Mayor, City of North Olmsted, Members of Council, Planning Commission and Landmarks Commission

Subj. Biddulph Trail proposal.

Cross Section Looking North

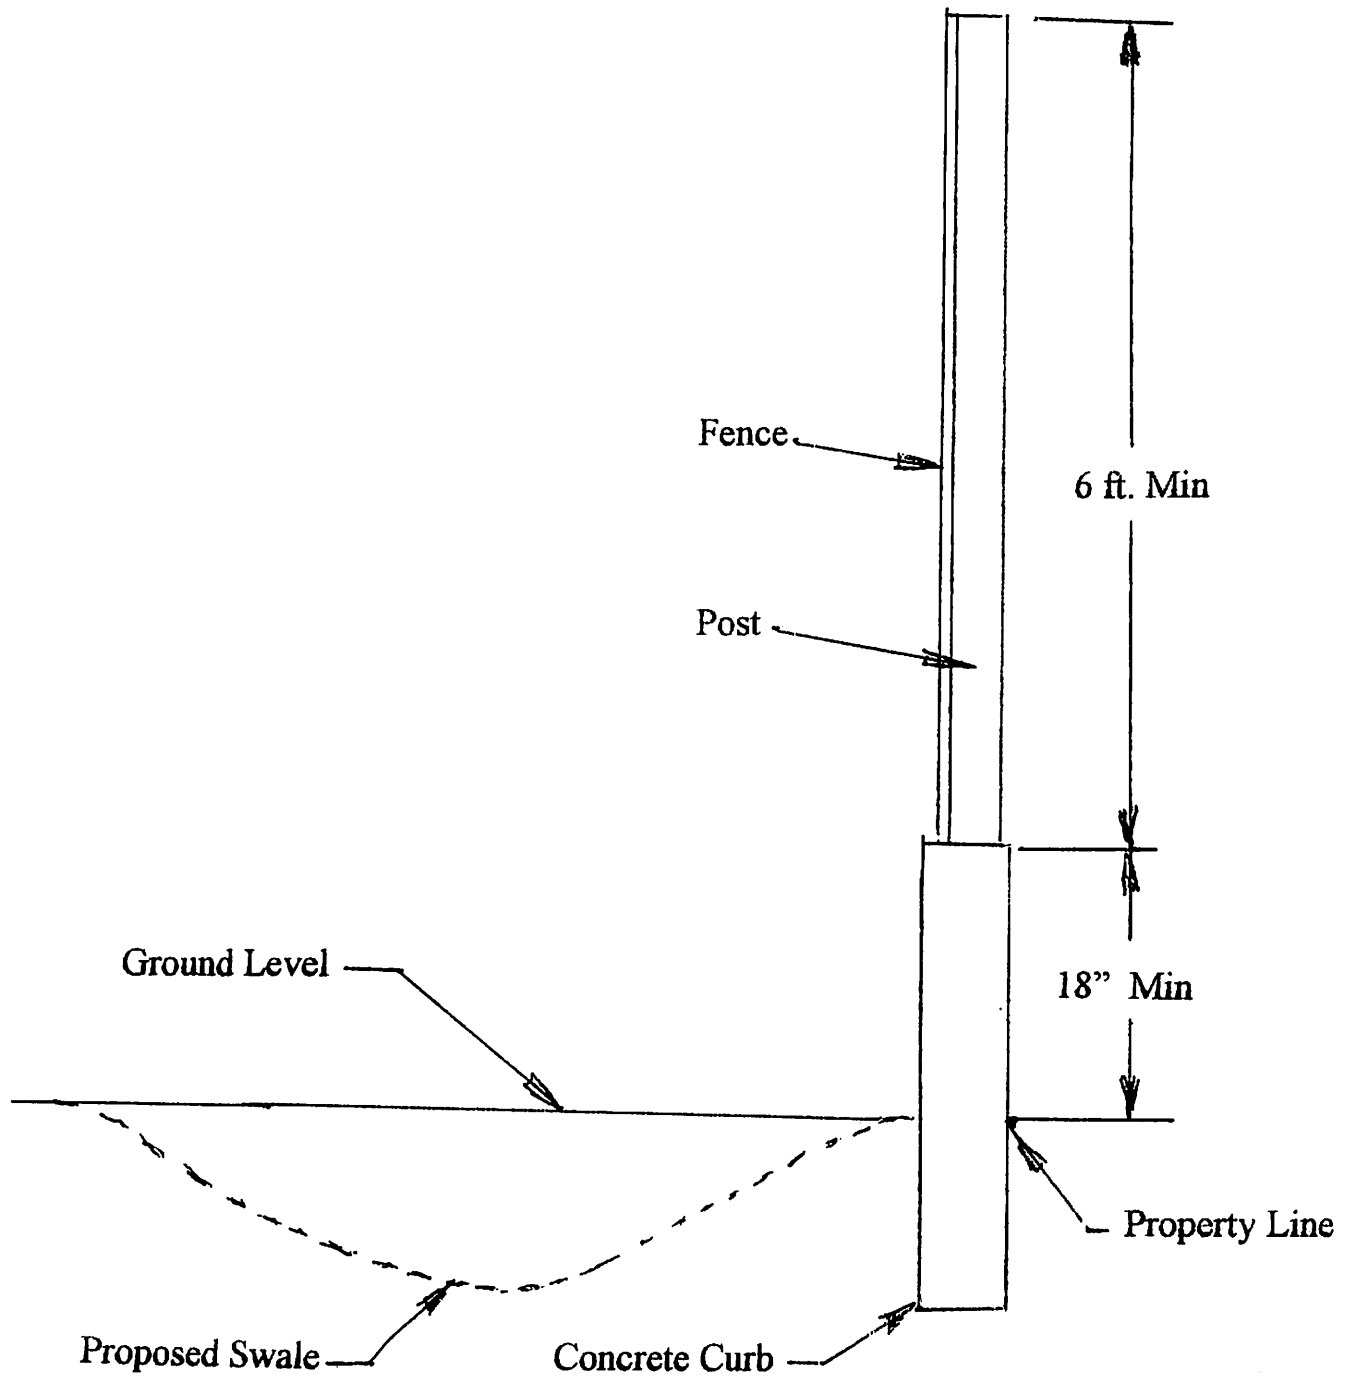
6. The last and most important point that I wish to make is that the swale shown on along the east boundary of the property is inadequate and there is insufficient room for a mound. The city engineer told me that even grass clippings will change a swale over time to say nothing about the effect of leaves and humans. I see is no assurance that the proposed homeowners association will keep that open and as designed. And, who will be responsible for

inspections. I think the swale should remain on the design as the first defense. Any water crossing the east boundary of the property north of the sanitary sewer will increase the storm flow through the natural gully which drains my property. This is where the gully passes underneath the sanitary where it is on fill dirt. That homeowner, the former city engineer, diligently watches the culvert there to assure it is kept open because if it is blocked, the underpinnings of the sanitary are lost and could collapse with disastrous consequences. There is a possible back up to the swale which I have described on an enclosed cross section sketch and with photographs. A curb could be built along the east boundary about 18 inches high that would be a backup to the swale. This backup would prevent water crossing the east boundary and take that water south of the sanitary and out of the picture and should be incorporated. I would also request a privacy and security fence above the curb and my neighbors to the south will request it be extended past their property as well. See attached illustration with photos of three similar installations in North Olmsted and one in Strongsville.

Before any work is begun on the site it is imperative that **all** runoff water be channeled to the south and into the existing large ditch that feeds through a large culvert that crosses under SR 252.
